February 5, 2013

**Subject: Model Water Quality Management Plan and Technical Guidance Document Errata;  
Order No. R8-2009-0030**

# TECHNICAL GUIDANCE DOCUMENT ERRATA SHEET #2

## FEBRUARY 5, 2013

TITLE	SUSCEPTIBILITY ANALYSIS SAN GABRIEL-COYOTE CREEK
JOB	ORANGE COUNTY WATERSHED MASTER PLANNING
SCALE	1" = 4000'
DESIGNED BY	
DRAWING BY	
CHECKED BY	
DATE	04/22/10
JOB NO.	9524E
FIGURE	XVI-3a

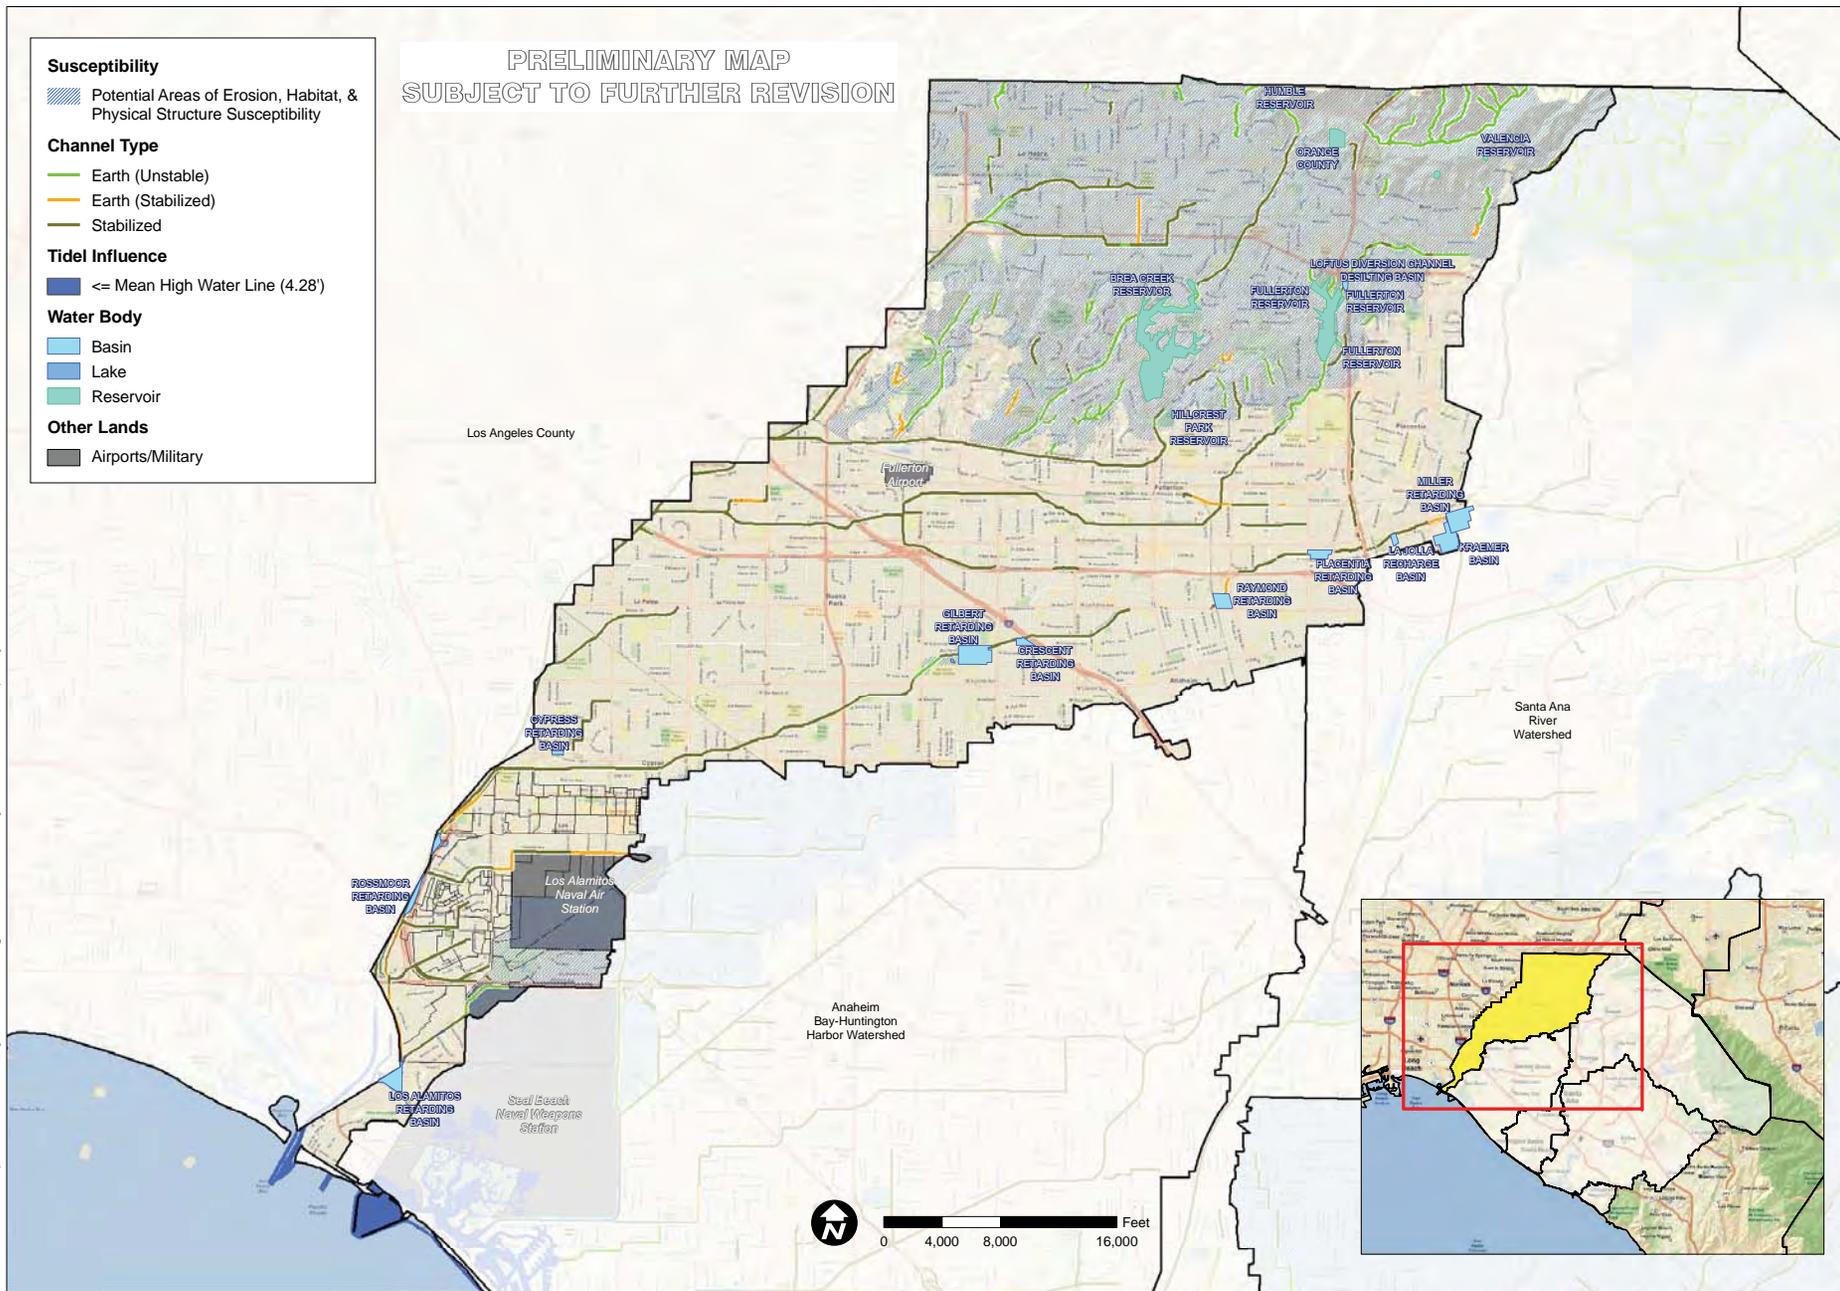
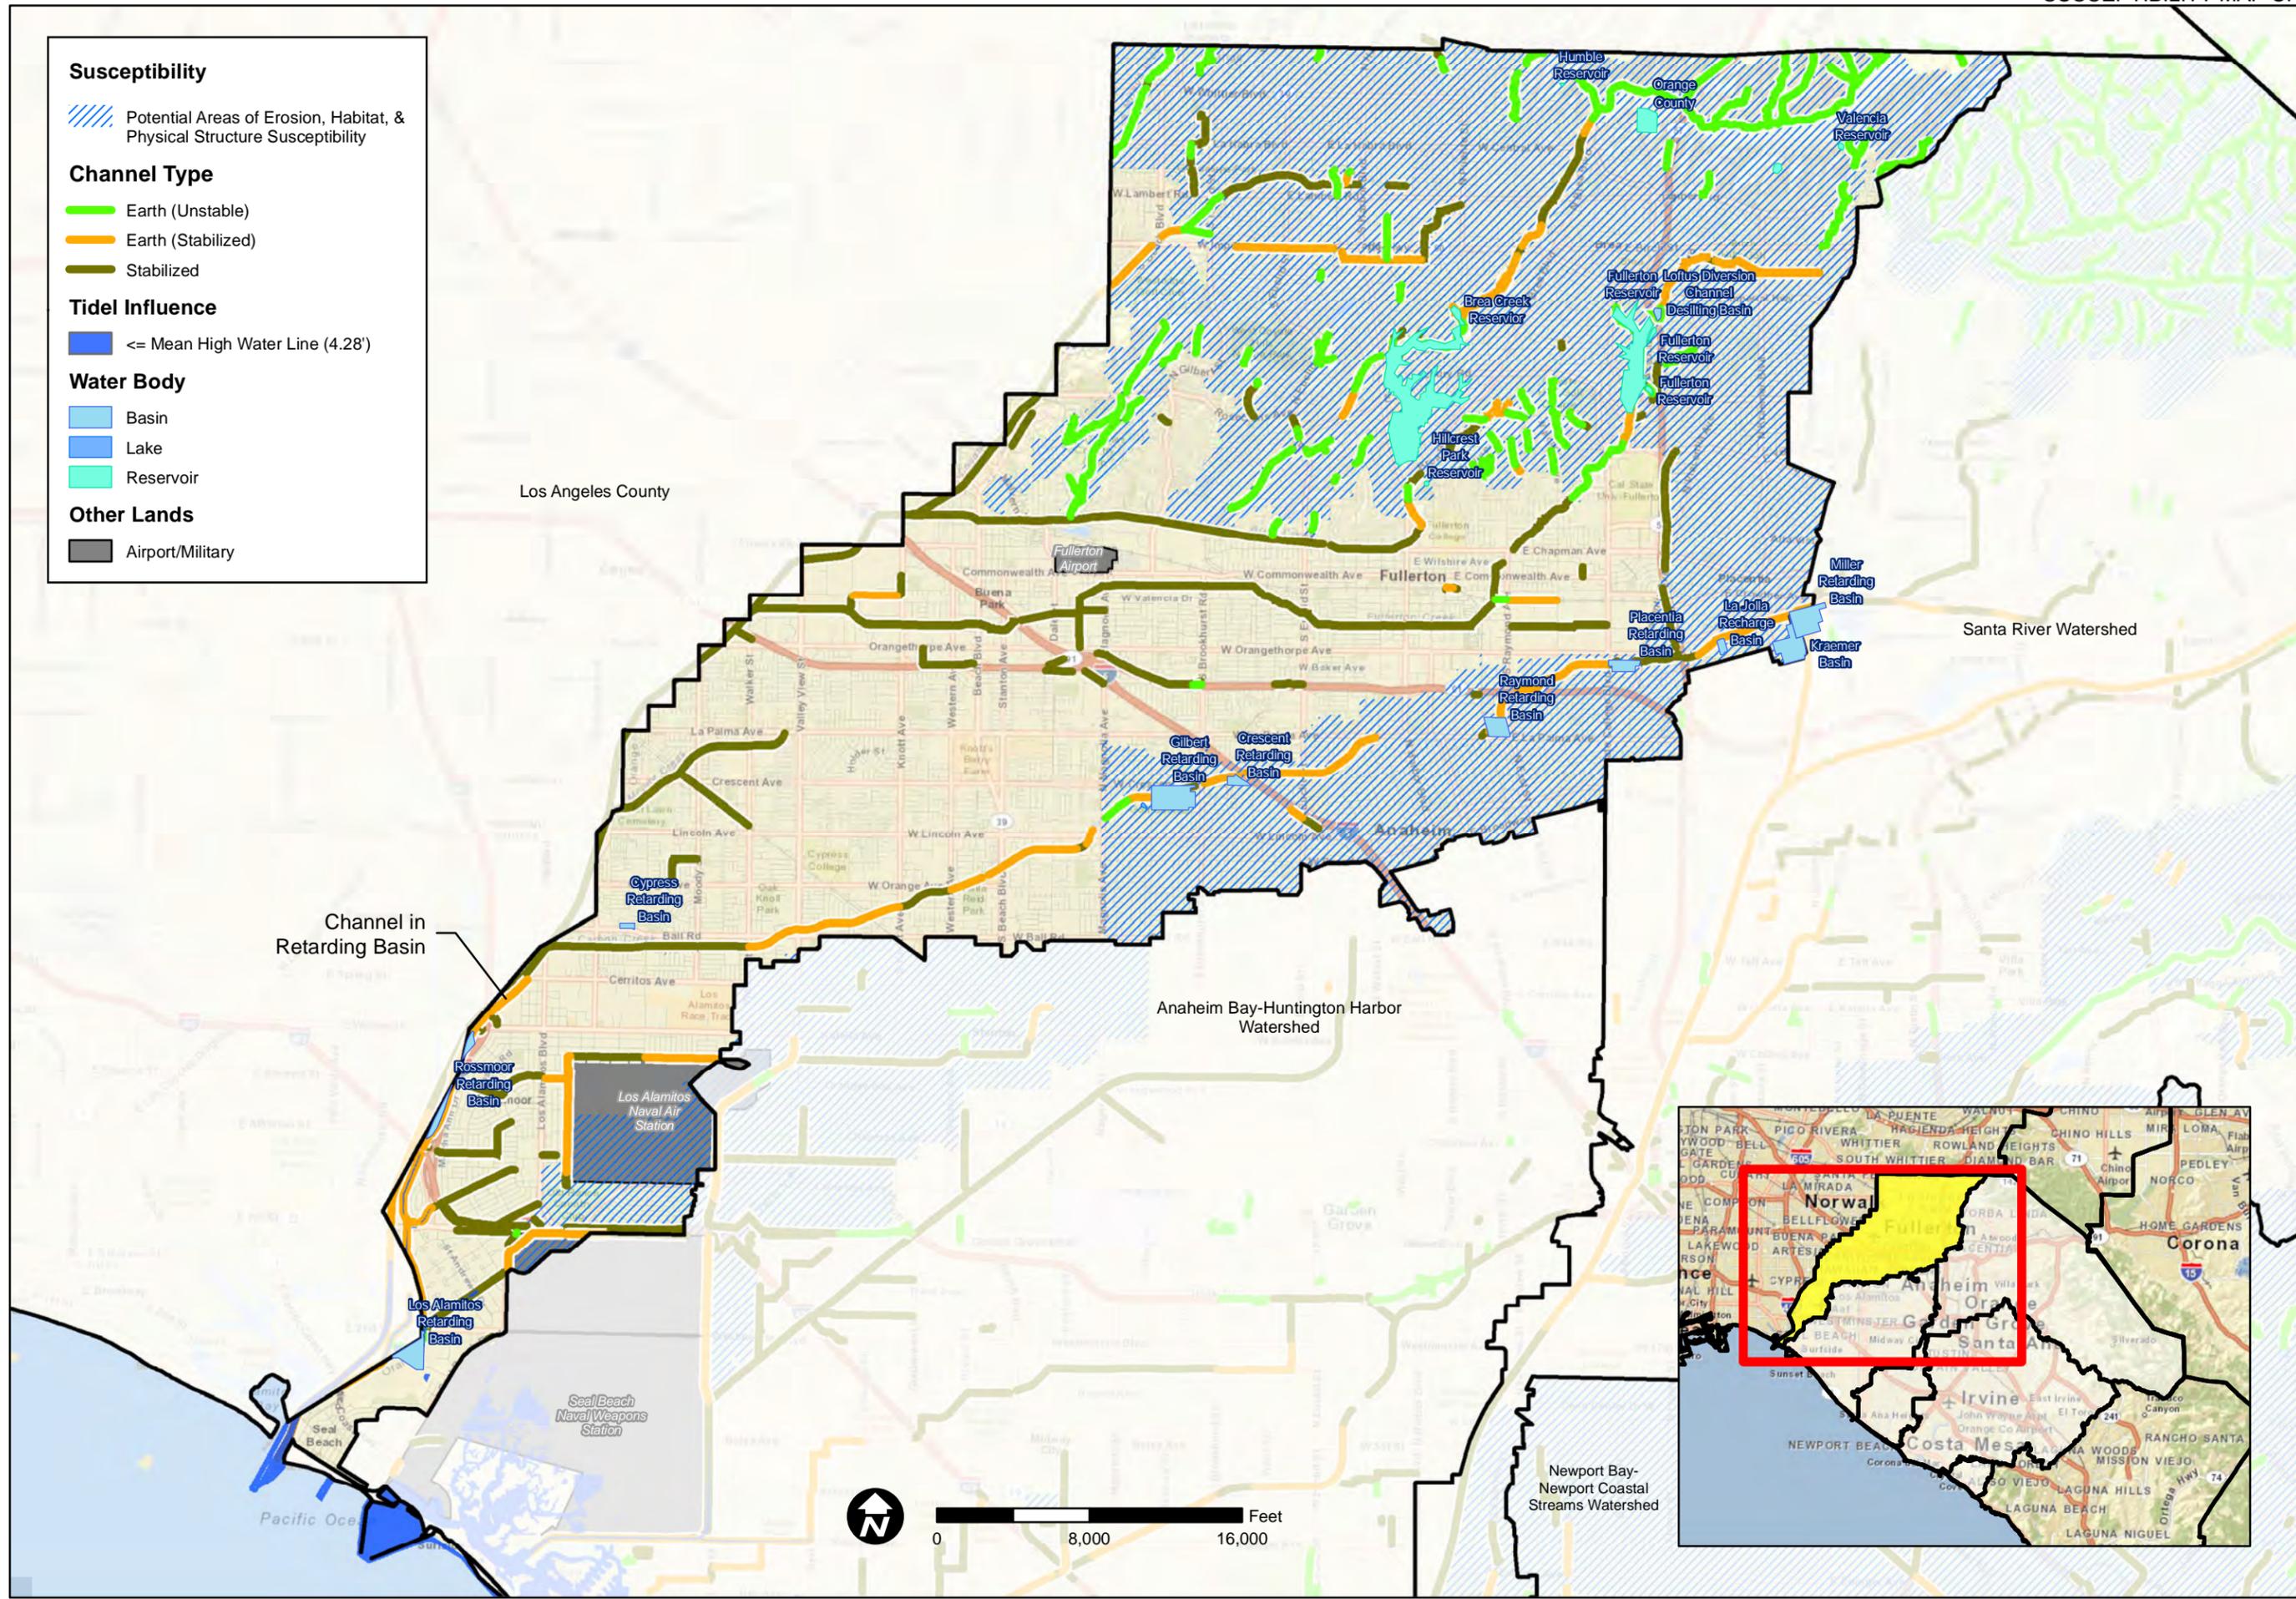
- Changes: A total of 8,879 linear feet of channel changed from Earth (Unstable) to Earth (Stabilized)
- Channels:
  - LOFTUS DIVERSION CHANNEL = 783 ft.
  - BUENA PARK STORM CHANNEL = 166 ft.
  - CARBON CREEK CHANNEL = 4,235 ft.
  - MONITECITO STORM CHANNEL = 125 ft.
  - ROSSMOOR STORM CHANNEL = 425 ft.
  - LOS ALAMITOS CHANNEL = 768 ft.
  - COYOTE CREEK CHANNEL = 400 ft.
  - BREA CANYON CHANNEL = 588 ft.
  - IMPERIAL CHANNEL = 627 ft.
  - FULLERTON CREEK CHANNEL = 182 ft.
  - FEDERAL STORM CHANNEL = 315 ft.
  - EAST LA HABRA STORM DRAIN = 44 ft.
  - BREA CREEK CHANNEL = 221 ft.
